Application for Licence Amendment

| Licence Number | L4247/1991/13 |
| Licence Holder | Talison Lithium Australia Pty Ltd |
| Premises | <p>Talison Lithium Mine</p> <p>Maranup Ford Road</p> <p>GREENBUSHES WA 6254</p> <p>Legal description -</p> <p>Mining tenements M01/3, M01/6, M01/7, M01/8, M01/9 and M1/16 L70/232 and L70/244</p> <p>General purpose lease G01/1 and G01/2</p> <p>As defined by the Premises maps in Schedule 1 and coordinates in Schedule 3</p> |

Figure 1: Schematic of the mine water circuit (GHD 2023).

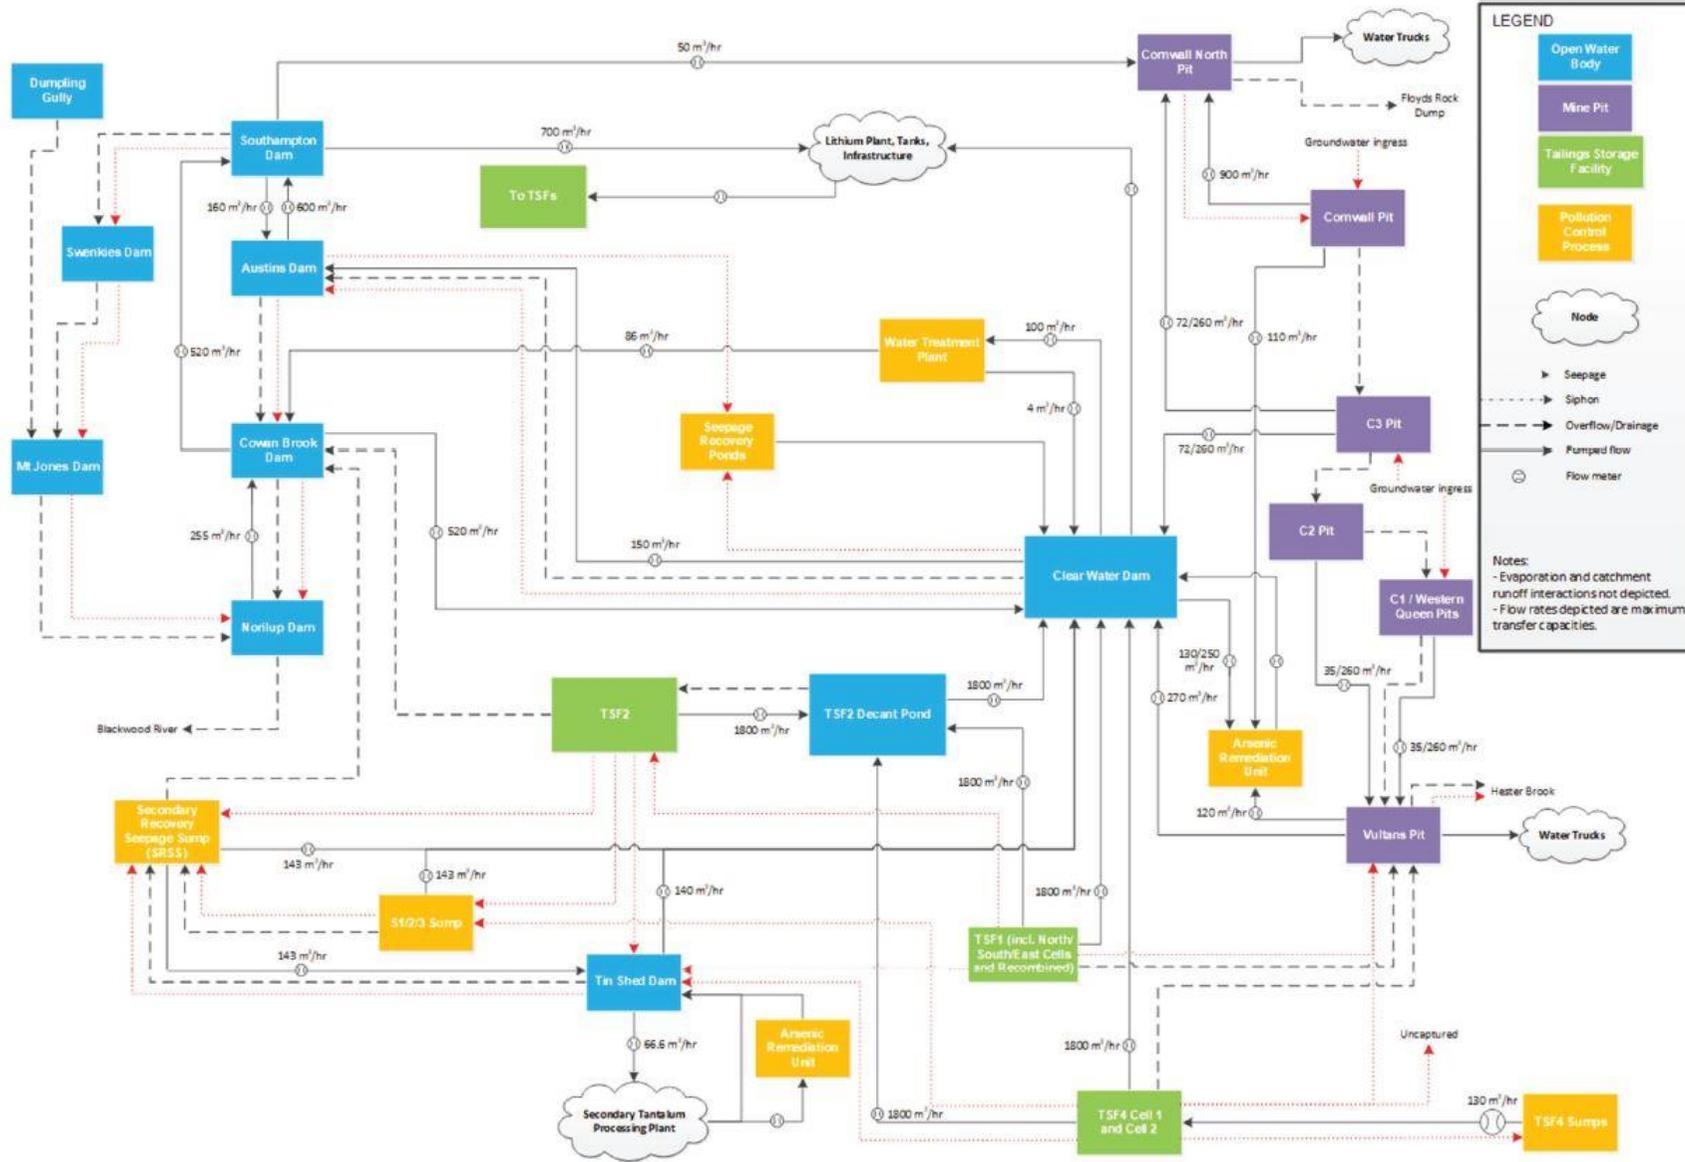
The ARU receives water from both mine pit dewatering activities and process water from CWD. Arsenic is removed through filtration and the application of ferric reagents. A schematic showing the mine water circuit is shown in Figure 1.

It is intended that leachate will be transported to the premises from the port via tanker trucks, where it is discharged into the Chemical Grade Plant #2 (CGP2) Wedge Pit (CGP2 Plant Wide Wedge Pit, Figure 2). Water collected in the wedge pit is currently reused in processing or reports to CWD for treatment via the existing water treatment system. It is estimated that one tanker (about 40kL) of wastewater will be received at the premises each day. By comparison, during the 2023-2024 reporting period, inputs into CWD from mine operations averaged about 2,287,000 kL per month (Talison 2024), indicating that the additional wastewater received from the port represents a minor to insignificant contribution to the daily water balance of the mine water circuit and process water directed to CWD.

Figure 3: Regional surface water system and water storage ponds (GHD 2023).

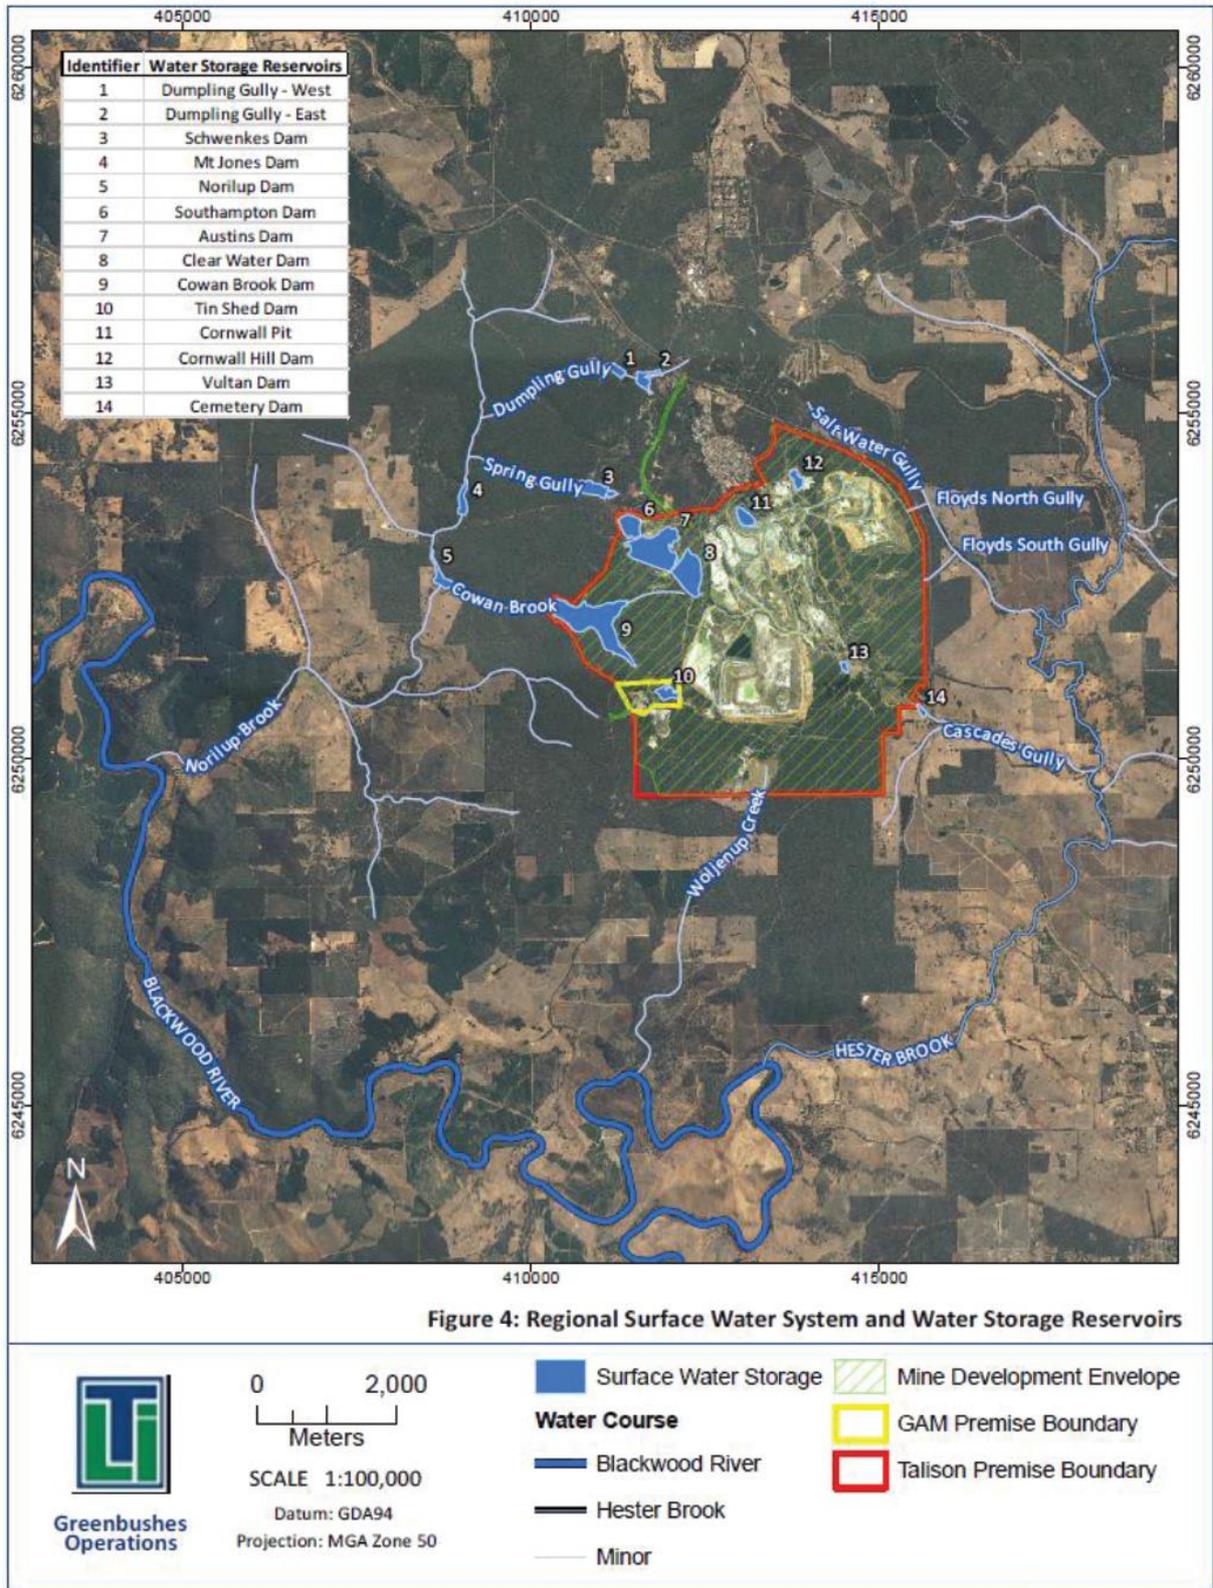
| Human receptors | Distance from prescribed activity |
|-------------------------------------|---|
| Surface water and groundwater users | <p>The mine water circuit allows transfer of water from CWD into surrounding water storage ponds such as Austins Dam, Southampton Dam and, Cowan Brook Dam. An overview of the regional surface water system and water storage reservoirs is provided in Figure 3.</p> <p>While the groundwater underlying the site is not recognised as a strategic resource areas (not listed as a proclaimed area) there are a number of residential users of surface and groundwater in the surrounding area.</p> <p>The results of a water survey carried out by the licence holder in 2021 indicates that downstream users access surface water from Norilup Brook, Hester Brook and Woljenup Creek for purposes including drinking water, domestic uses such as showering, laundry, water for gardens, recreational activities (including swimming), aquaculture activities, irrigation for crops and stock water. The nearest property is 2.3km west of CWD and 750m south-west of Cowans Brook Dam (Figure 4).</p> |
